# Beauly to Blackhillock to New Deer to Peterhead 400kV OHL

Alignment Report on Consultation

January 2025

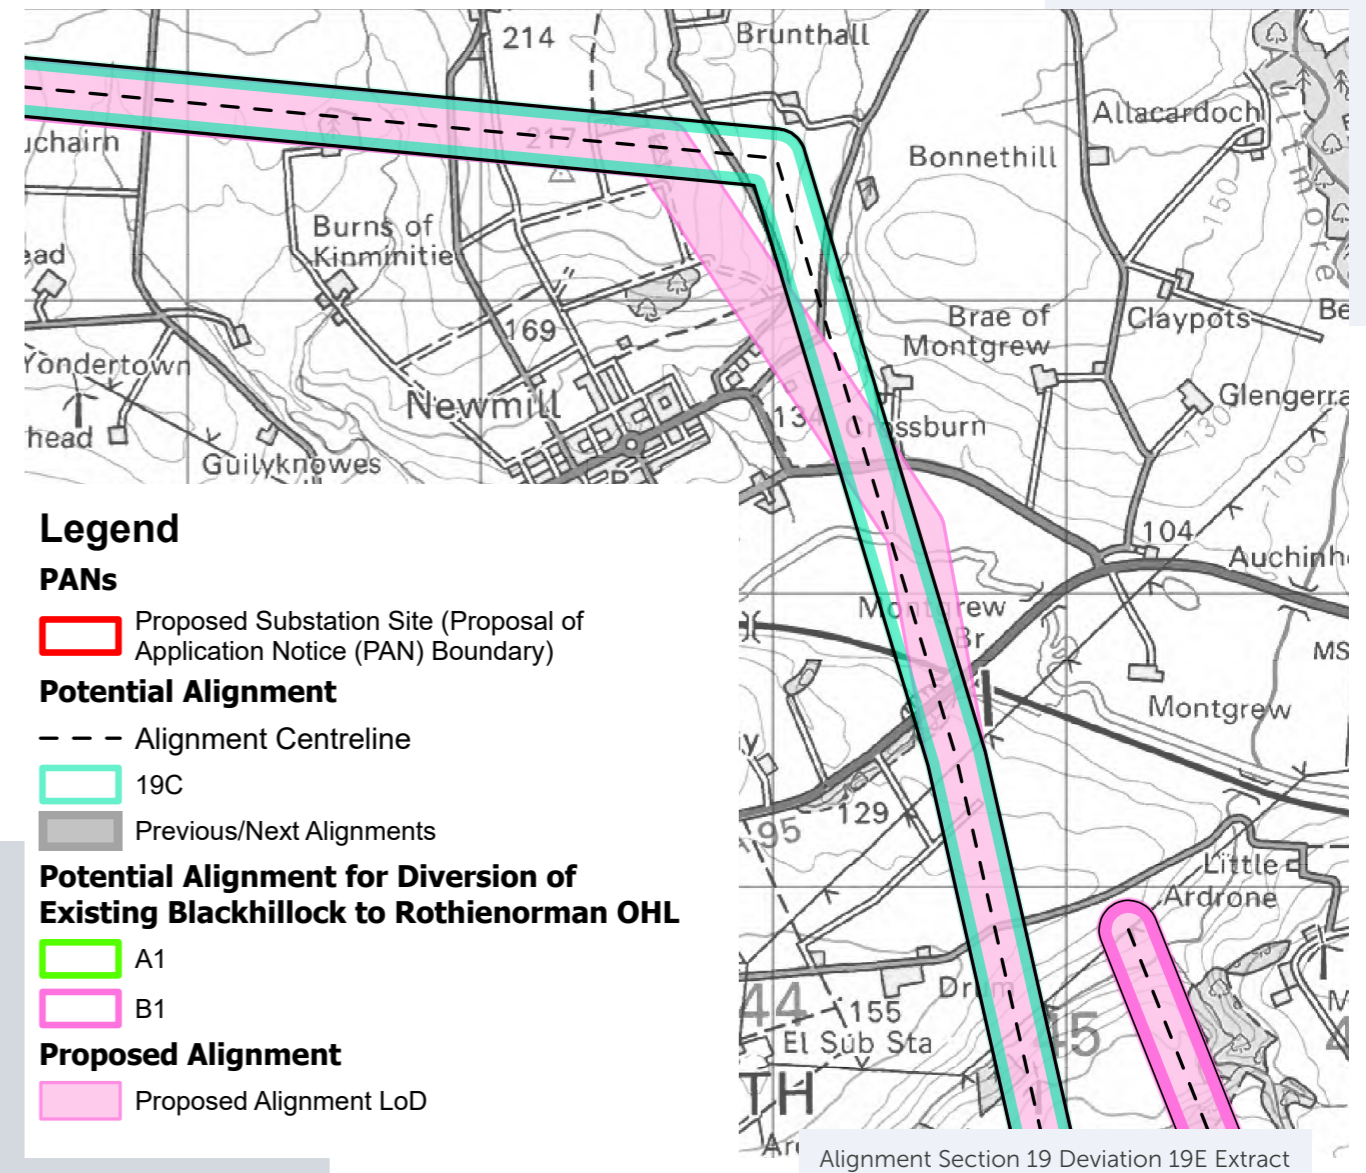
In Section 19 we identified an alignment deviation (Alignment 19E) that crosses the River Isla at a slightly more easterly point than the Potential Alignment 19C, to prevent interference with dredging requirements of the River Isla. Consequently, it takes a gentler angle as it comes around the north of Newmill to maintain distances from residential properties. Further assessment concluded that Alignment 19E is acceptable from an environmental, engineering and cost perspective in comparison to the Potential Alignment 19C. Further information is provided in the Alignment Deviations Appraisal in Appendix C.

Alignment 19E will therefore be taken forward as the Proposed Alignment for EIA and detailed design.

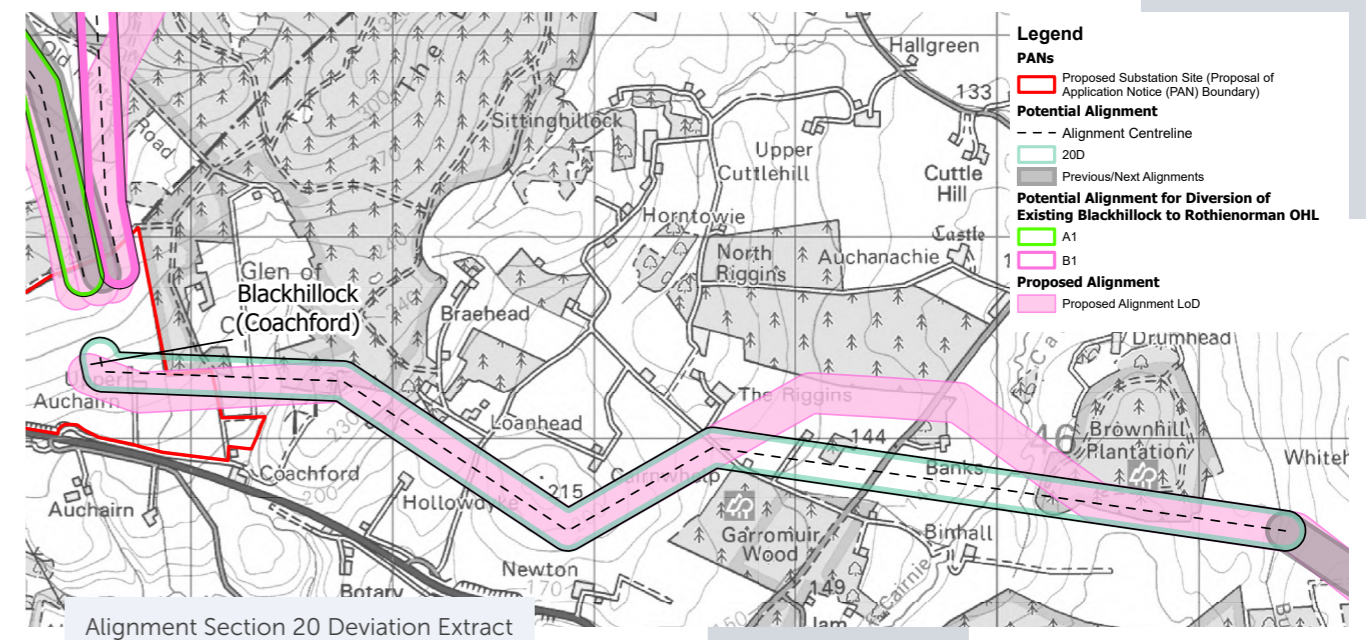
Following review of consultation feedback in Section 20, we identified an alignment deviation (Alignment 20G) that takes a more northerly alignment to Potential Alignment 20D over a short distance north of Garrowmuir

Wood, to move further from properties and avoid a pond crossing. Further assessment concluded that Alignment 20G is acceptable from an environmental, engineering and cost perspective in comparison to the Potential Alignment 20D. Further information is provided in the Alignment Deviations Appraisal in Appendix C.

Alignment 20G will therefore be taken forward as the Proposed Alignment for EIA and detailed design.

### Route Section 10 (Alignment Section 25) – south of Turriff to New Deer

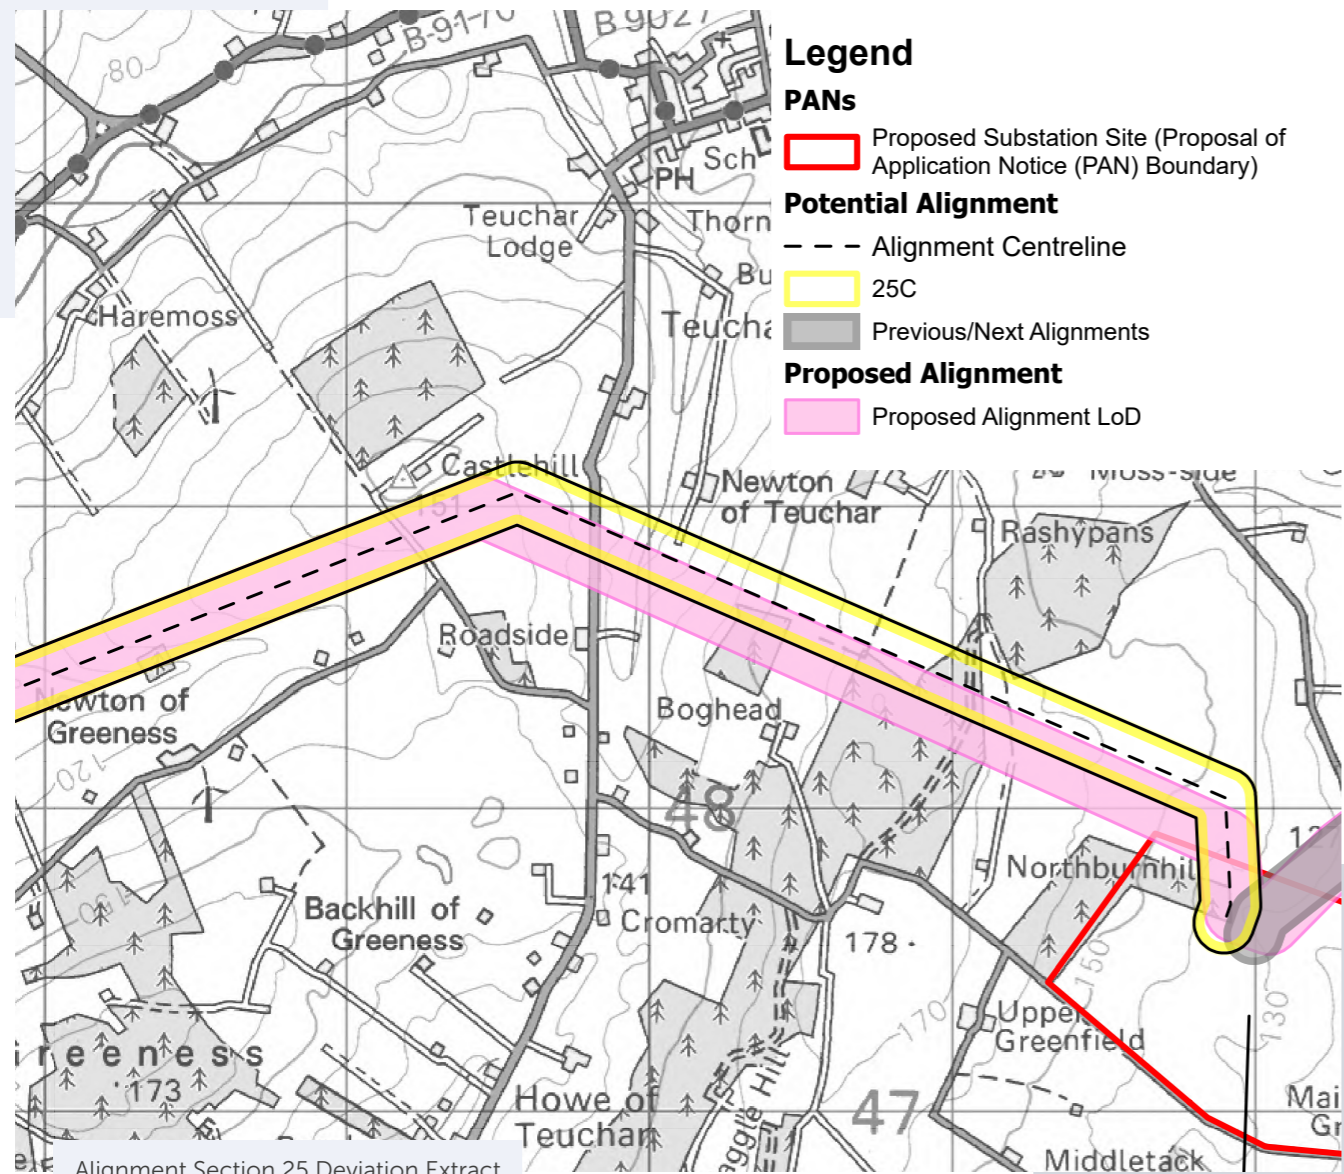
Following review of consultation feedback in Section 25, we identified an alignment deviation (Alignment 25D) that takes a more southerly route than Potential Alignment

25C to stay closer to field margins and to reduce limitations to future land use. Further assessment concluded that Alignment 25D is acceptable from an environmental, engineering and cost perspective in comparison to the Potential Alignment 25C. Further information is provided in the Alignment Deviations Appraisal in Appendix C.

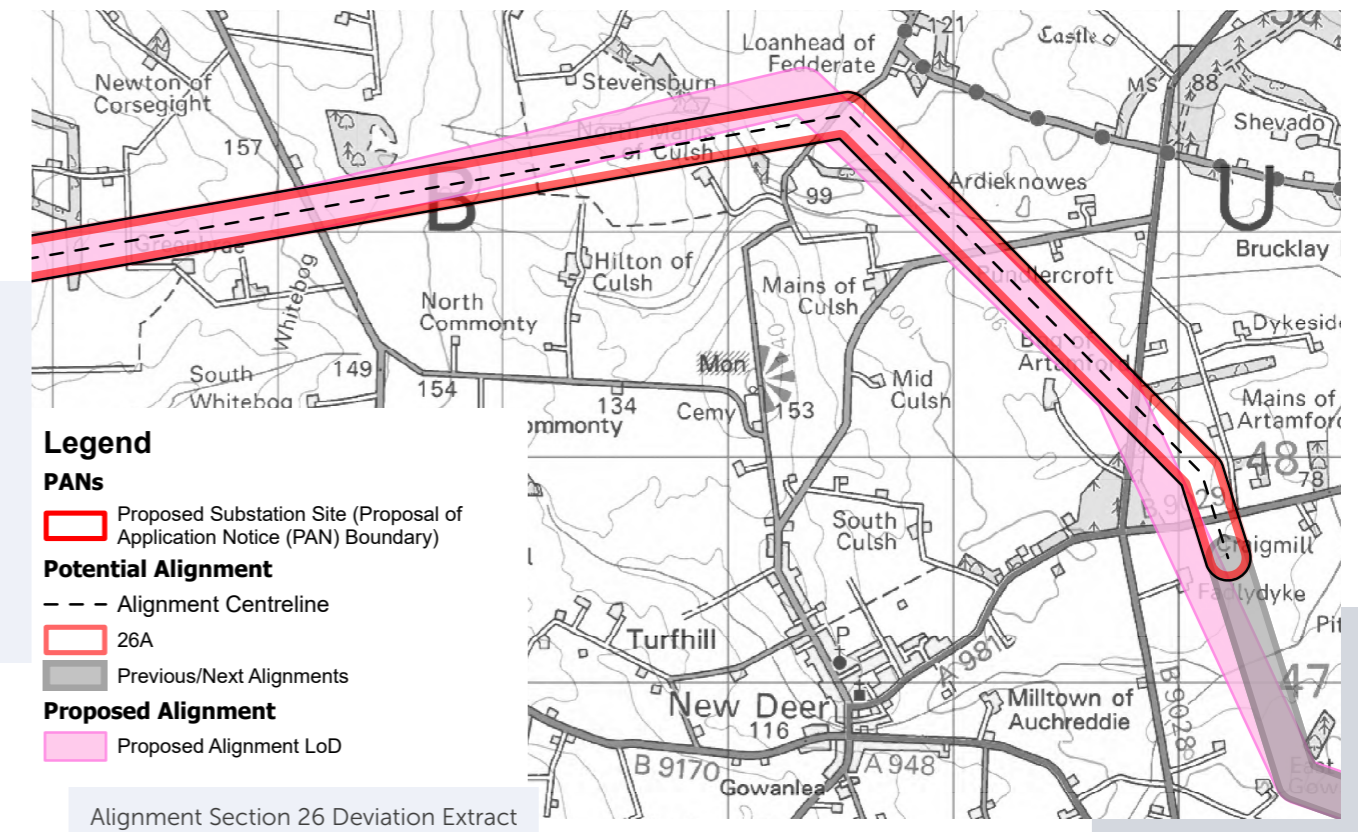
In Section 26, we identified an alignment deviation (Alignment 26E) which accommodates a landowner request to move the alignment slightly further from their main property. It takes it closer to a second property, however it is one that they also own and is not occupied. This deviation extends into the western end of Section 27. Further assessment concluded that Alignment 26E is acceptable from an environmental, engineering and cost perspective in comparison to the Potential Alignment 26A. Further information is provided in the Alignment Deviations Appraisal in Appendix C.

Alignment 26E will therefore be taken forward as the Proposed Alignment for EIA and detailed design.

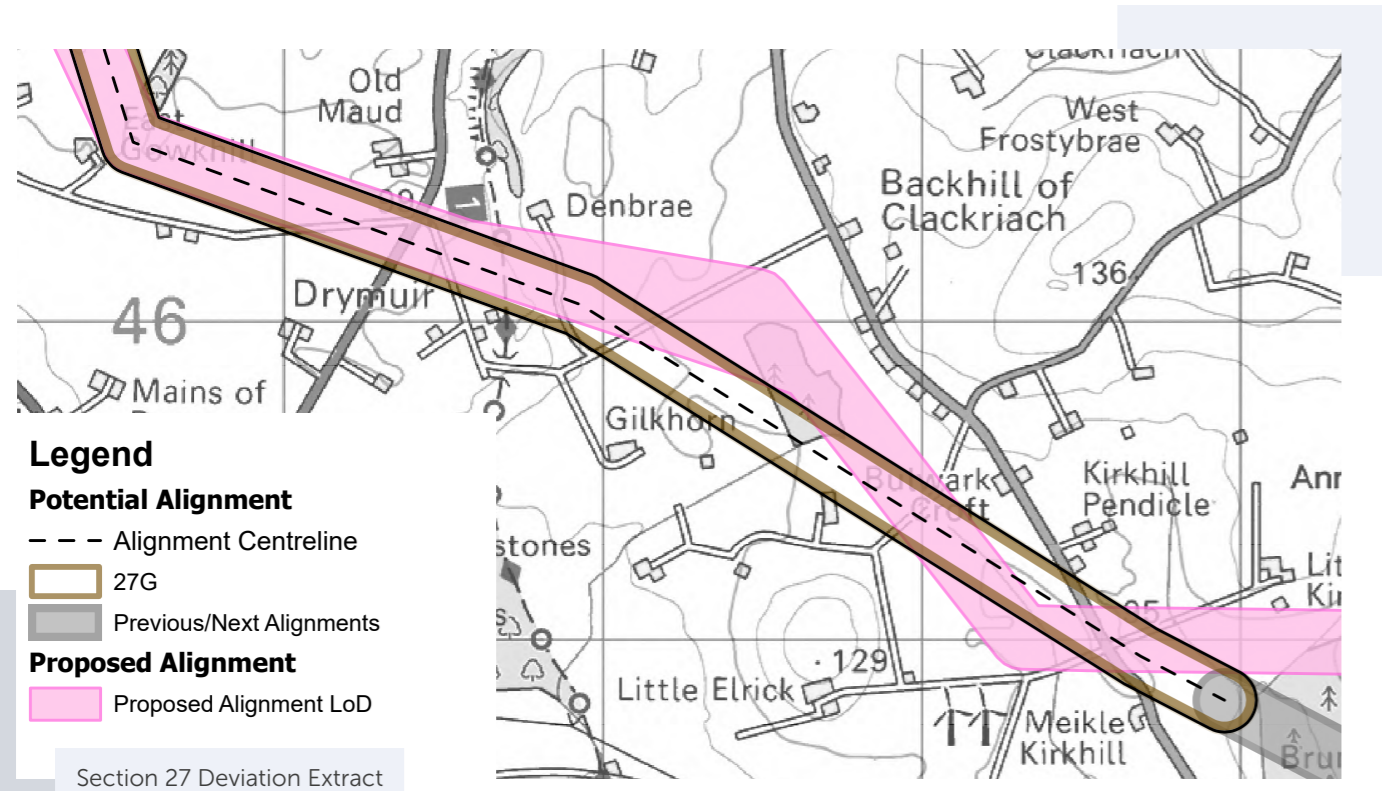
In Section 27 we identified an alignment deviation (Alignment 27H) that deviates from the Potential Alignment 27G in order to avoid two residential property planning applications and to accommodate landowner feedback. Alignment 27H is also slightly widened in this area, to allow greater flexibility for tower positioning to avoid emergency telecommunications links and a private water supply identified through site surveys. Further assessment concluded that Alignment 27H is acceptable from an environmental, engineering and cost perspective in

comparison to the Potential Alignment 27G. Further information is provided in the Alignment Deviations Appraisal in Appendix C.

Alignment 27H will therefore be taken forward as the Proposed Alignment for EIA and detailed design.

The final tower positions within the widened section will be confirmed at the next round of consultation events.

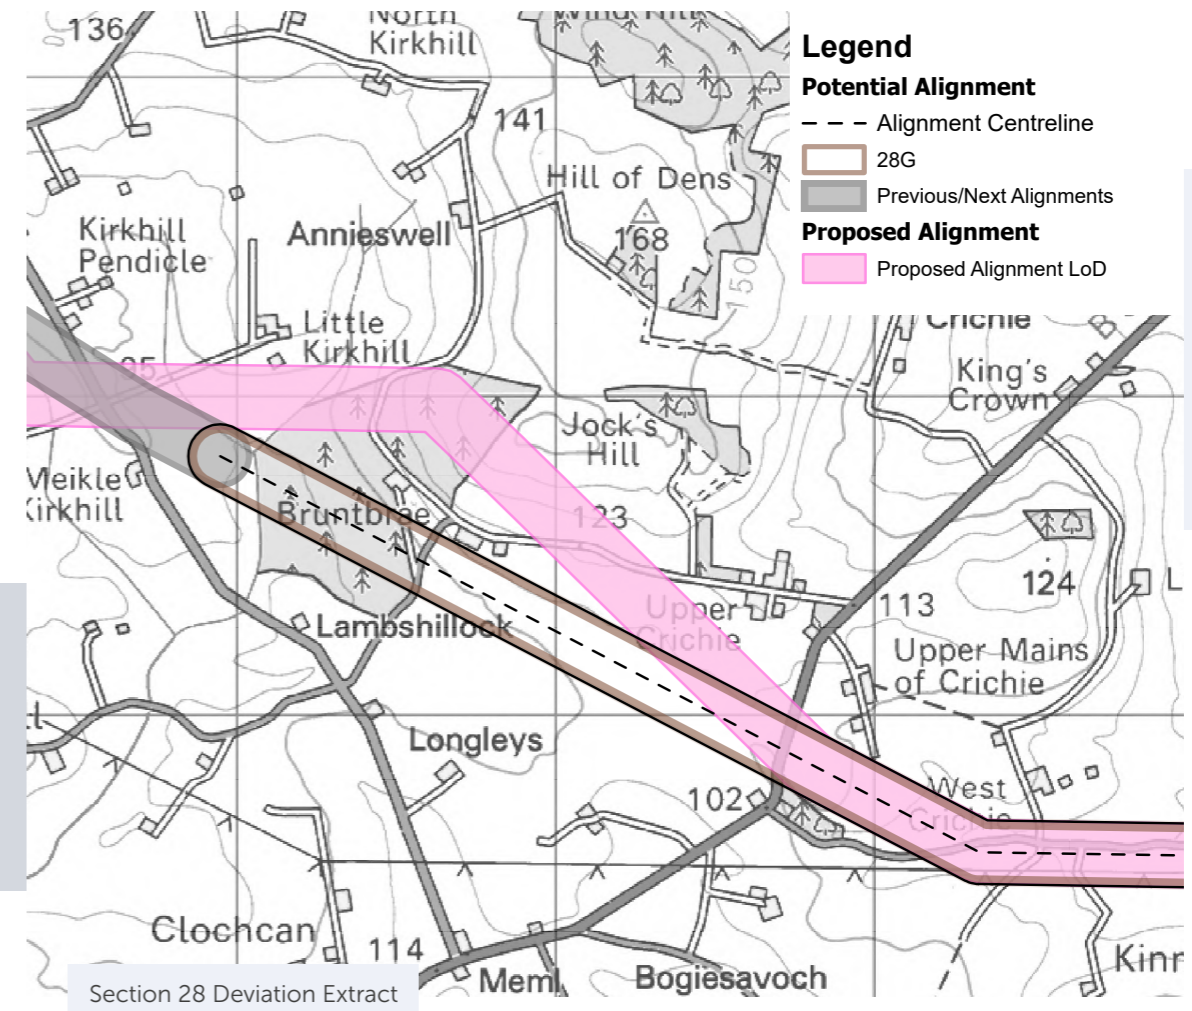
As a result of the changes made to the Proposed Alignment in Section 27, we identified an alignment deviation in Section 28 (Alignment 28H), as the approach to Section 28 from the west is different. Alignment 28H is similar to Alignment 28E (considered as an alignment option and presented at the alignment consultation events) which had similar outcomes to the Potential Alignment in the alignment studies, however it crosses Jock's Hill at a lower elevation than Alignment 28E. Alignment 28H also follows field margins more closely,

accommodating a landowner request in this area. Further assessment concluded that Alignment 28H is acceptable from an environmental, engineering and cost perspective in comparison to the Potential Alignment 28G. Further information is provided in the Alignment Deviations Appraisal in Appendix C.

Alignment 28H will therefore be taken forward as the Proposed Alignment for EIA and detailed design.
